Subject: Mine Ventilation Plan, Section 75.370, 30 CFR 75, Upper  
Big Branch Mine-South, I.D. No. 46-08436, Performance  
Coal Company, Montcoal, Raleigh County, West Virginia

Re: Ventilation Revision  
Upper Big Branch Mine – South  
Panel 20 Pillaring  
MSHA ID: 46-08436

# Typical Section Retreat

### For Headgate 20

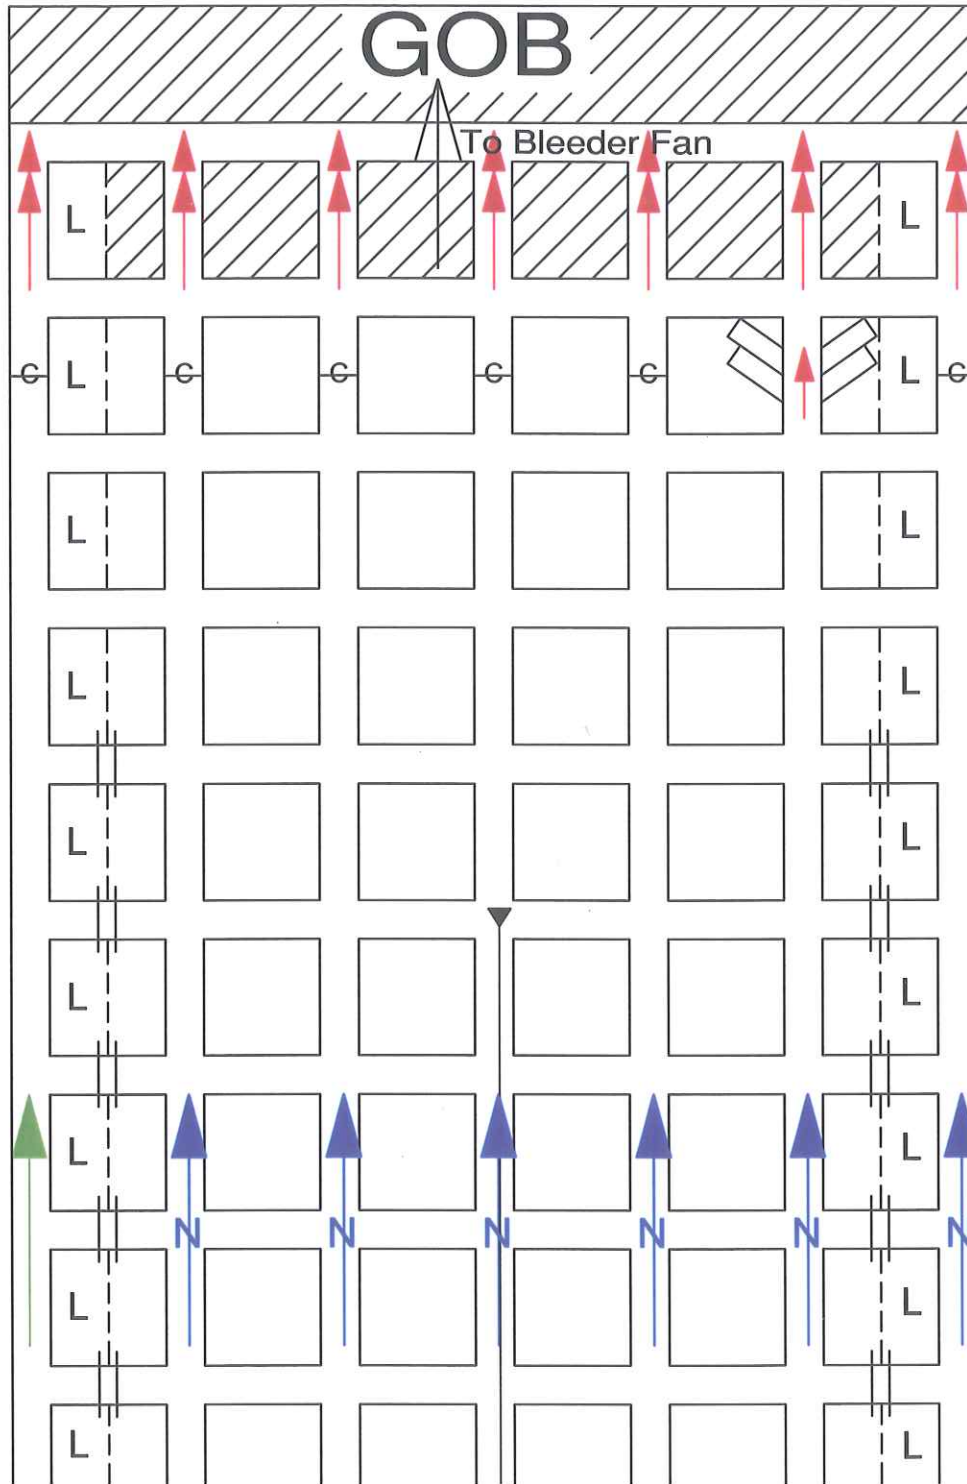
Performance Coal Company, Upper Big Branch-South (ID 46-08436), is requesting permission to pillar mine in the Headgate 20 Section. The air will be dumped into the longwall bleeder system. Ventilation controls and the Final EP location will be situated according to the attached map. Also included is a typical face sketch for the pillar section for Headgate 20 only.

TYPICAL CRIP BLOCK STOPPING

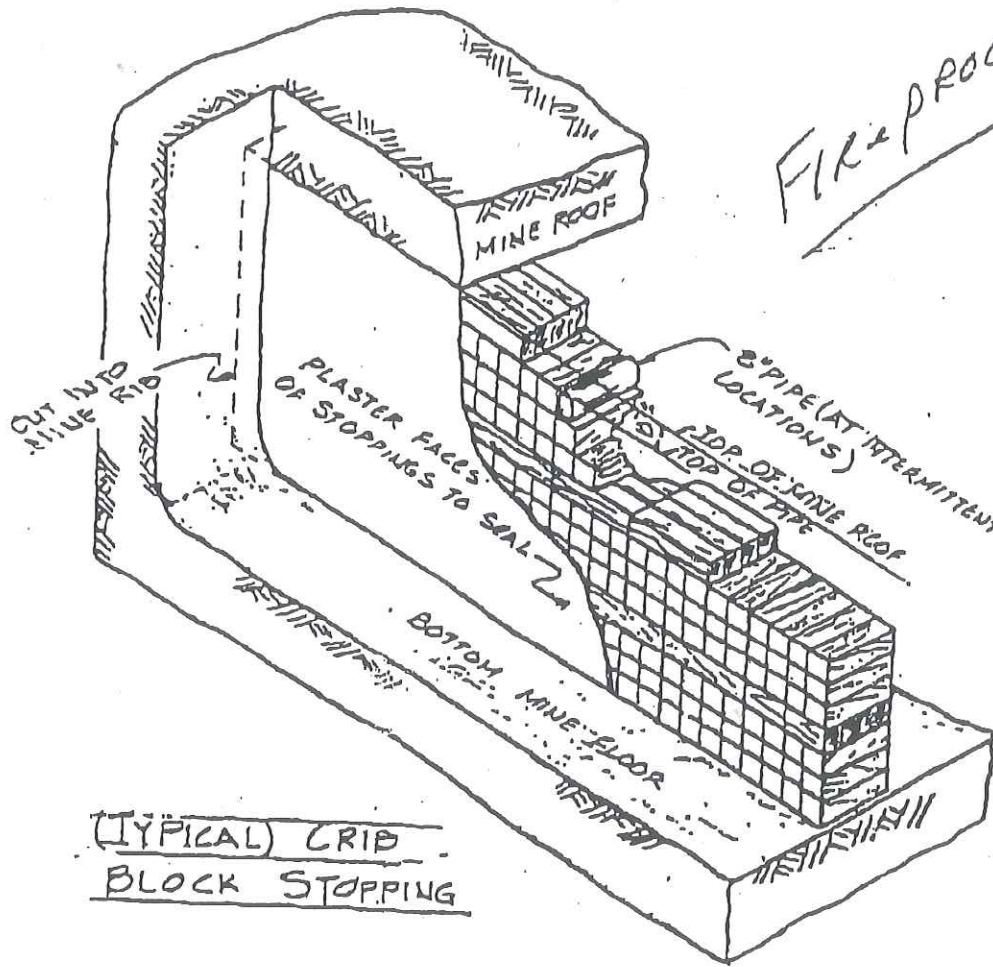
Please note the location of the proposed “crib block” stopping between Headgate 20 and Headgate 19. These stoppings will be constructed prior to any pillaring on Headgate 20 and Performance Coal Company will notify the appropriate Mine Safety and Health Administration, District 4 personnel to allow inspection of the crib block stoppings prior to the commencement of pillaring Headgate 20.

1. Crib Block Stoppings will be constructed of minimum 6"x6"x24" timber (minimum) in areas where severe roof conditions are expected and ventilation controls must be maintained for an indefinite period of time.
2. Construction of stopping will be similar to that indicated above. At intermittent locations, an opening (e.g. pipe) may be left at the top for air bleed and/or bottom for water flow.
3. Crib Stopping will be wedged into place and all openings and cracks plastered shut, and painted with fire resistant paint.
4. Where the crib stopping is to be used as a regulator, a minimum of four-eight inch dia. pipes will be installed.
